**GENERAL PURPOSE WAREHOUSE, BUILDING 732
DEFENSE DISTRIBUTION CENTER/DISTRIBUTION DEPOT SUSQUEHANNA PENNSYLVANIA (DDC/DDSP),
NEW CUMBERLAND, PENNSYLVANIA**

AMENDMENT NO. 0008 TO RFP W912DR-04-R-0062
EFFECTIVE NOV 23, 2004

SKE-10

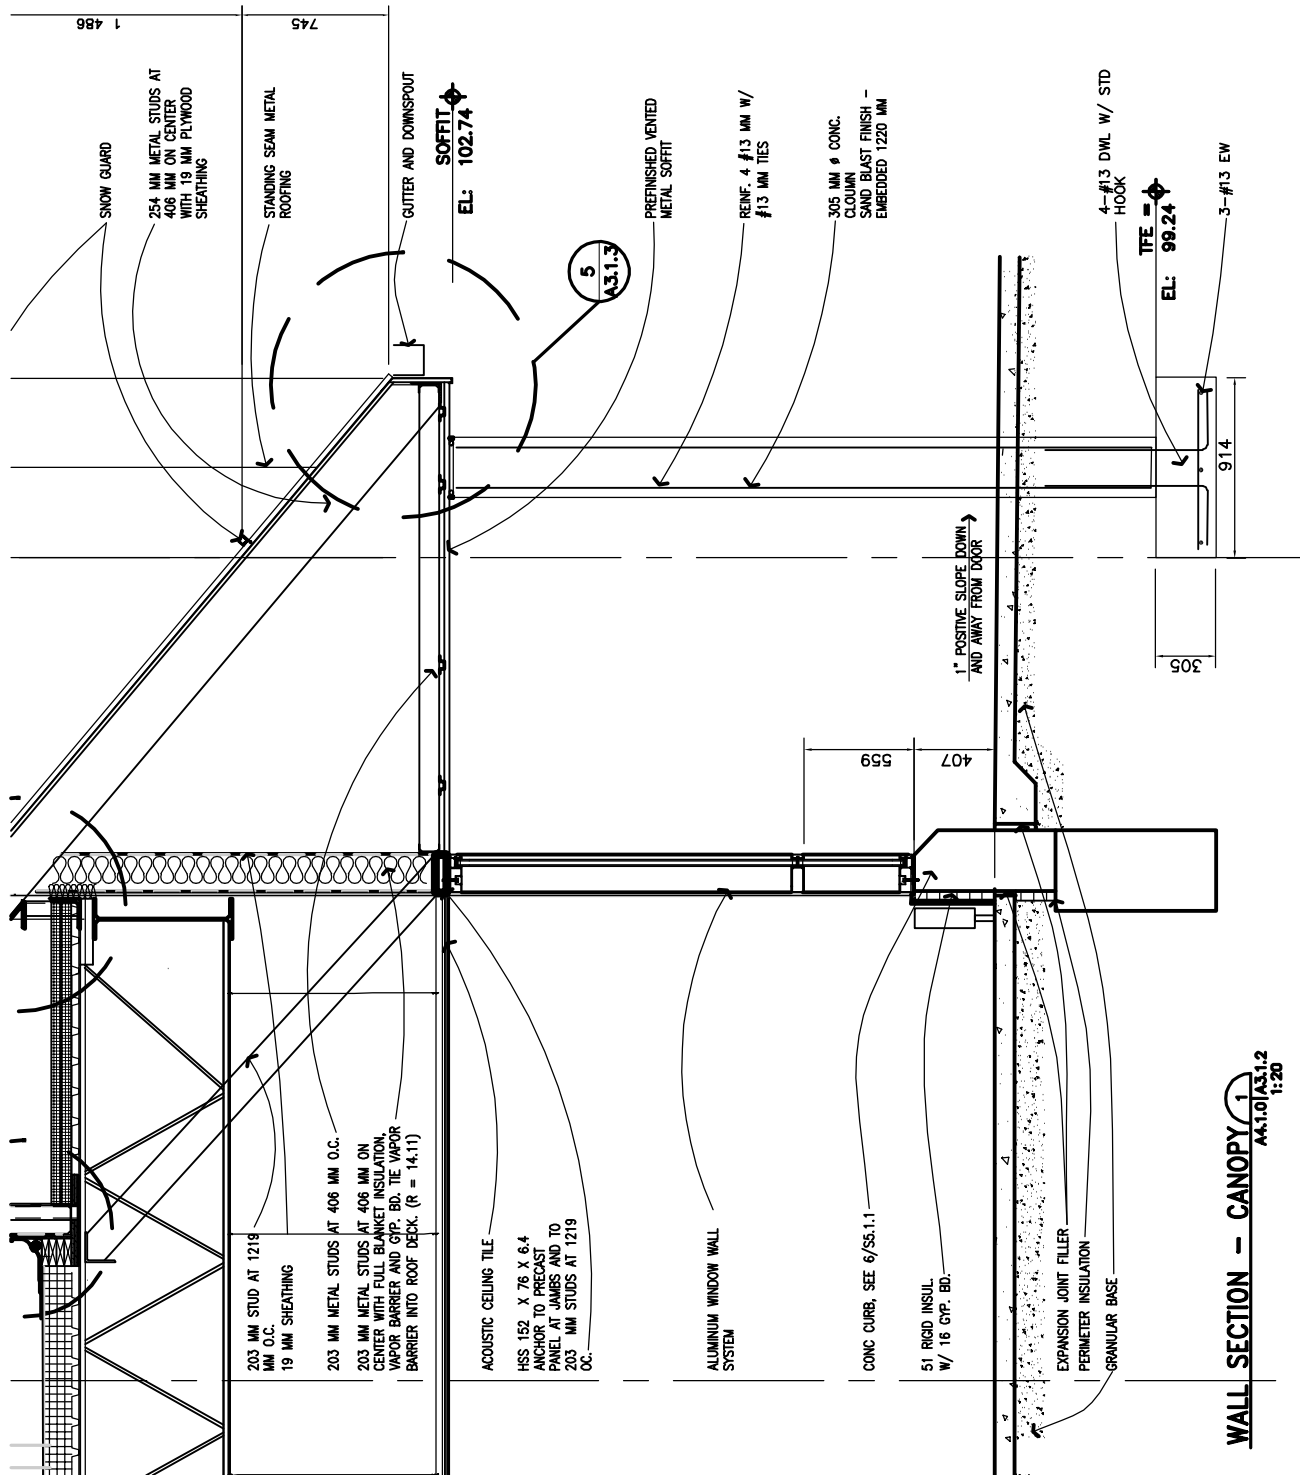
- b) Sheet A3.1.4, Detail 6/A3.1.4: Revise as shown on attached Sketch SKE-10, dated 11/19/04.
 - c) Sheet E0.1.1: Delete disconnect switch, feeder, and connection to air compressor AC-1 on MDS-FP one-line diagram.
